## **ADDENDUM TO SERVICE BULLETIN S04JC**

# MPX Modification

All Blue Bird Visions with Version 1 multiplex systems, and certain Blue Bird Visions with Version 2 multiplex systems.

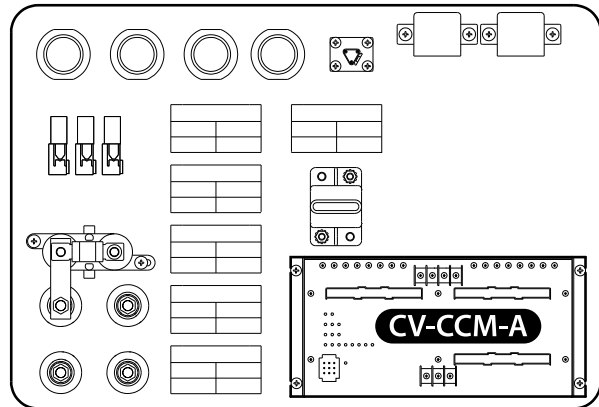
**Version 2** units have one MPX module, and its model designation is CV-CCM-A. If the vehicle is Version 2, proceed as follows:

- 1.1** Unplug the harness blocks from the module. Remove the four mounting screws, and remove the module.
- 1.2** Mount the new module. Reconnect the harness blocks. This is the only modification required.
- 1.3** Go to step 12 of this procedure.

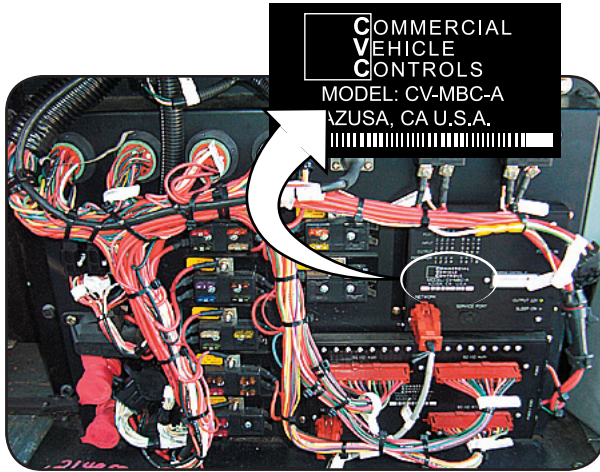
**2** Steps 2–10 of this procedure apply **only** to Vision buses with Version 1 Multiplex systems. Version 1 systems are those with two separate MPX modules in the PDU, as shown, with Main Bus Controller module model number CV-MBC-A.

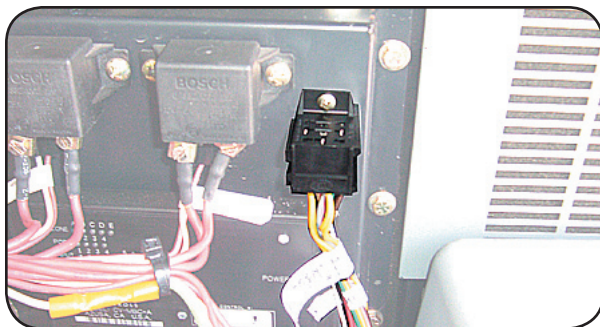
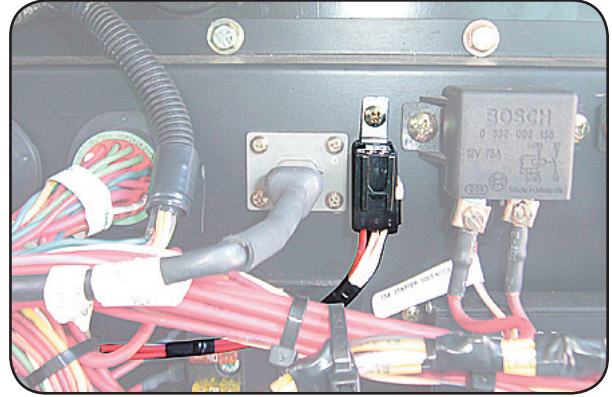
**3** Drill a  $\frac{5}{32}$  hole to attach the Diode Block connector of the new harness to the PDU box in the location shown. Attach with a short #10 self tapping sheet metal screw. Insert the Diode Block (0081525) into the connector.

**CAUTION** Use a short drill bit. Drill slowly and only through the sheet metal, being mindful of components which may be on other side of the panel.

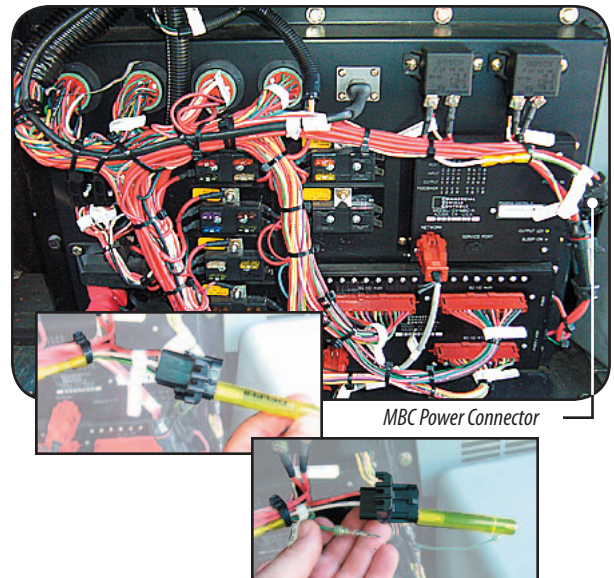
**4** Similarly mount the Micro Relay Socket of the new harness in the location shown. Insert Micro Relay (1746387) into the socket. Take the same precaution to avoid drilling deeply and possibly damaging components on other side of the panel.

**5** Unplug MBC Power connector (far right side of image). Slide yellow pin removal tool over the pin of the green wire (labeled SYS WAKE). Pull the green wire from the connector.

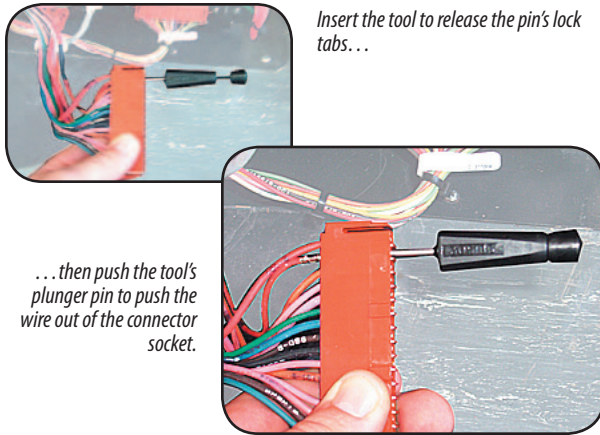
**6** Insert the green wire of the new harness labeled SYS WAKE into the socket from which the original green wire was removed in step 4. Reconnect the MBC Power connector.

**7** The green wire removed in step 4 is spliced into a white wire, labeled Wake Up, at a yellow butt connector located a few inches from the MBC Power Connector. Cut the white wire on both sides of the yellow butt connector. Discard the yellow butt connector and the green wire end. Then reconnect the two cut ends of the white wire back together with a new butt connector.

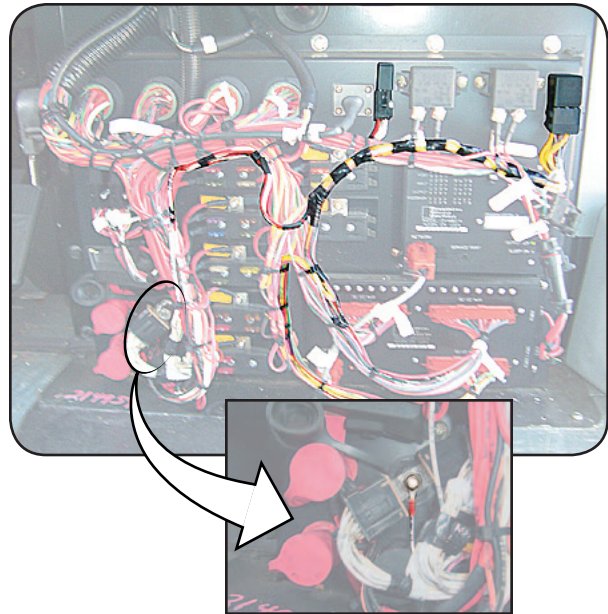
**8** The photos below show how to use the black pin removal tool. The tool is inserted over the pin to be removed. This retracts the lock tabs of the connector pin. Then depressing the tool's plunger pushes the pin out of the connector block.

Use the black pin removal tool to remove the wires at the following six locations. Replace each removed wire with the corresponding wire of the new harness:

- Remove wire labeled B1-O14 from Port B1 connector, pin 14. Insert wire labeled B1-O14A from new harness into same socket.
- Remove wire labeled B2-O08 from Port B2 connector, pin 08. Insert wire labeled B2-O08A from new harness into same socket.
- Remove wire labeled B2-I02 from Port B2 connector, pin 02. Insert wire labeled B2-I02A from new harness into same socket.
- Remove wire labeled B3-O04 from Port B3 connector, pin 04. Insert wire labeled B3-O04A from new harness into same socket.

- Remove wire labeled B3-O05 from Port B3 connector, pin 05. Insert wire labeled B3-O05A from new harness into same socket.
- Remove wire labeled B3-O14 from Port B3 connector, pin 14. Insert wire labeled B3-O14A from new harness into same socket.

**9** The 6 wires just removed will now be connected to the corresponding butt connectors on the new harness. Before making these connections, plan the routing of harness so it can be neatly bundled when finished. Then route the six removed wires toward the harness. For each of the six original wires, cut the pin off, leaving an appropriate length of wire for connecting to the new harness butt connector. The wires of the new harness with the butt connectors attached are labeled identically to the original wires you are connecting.
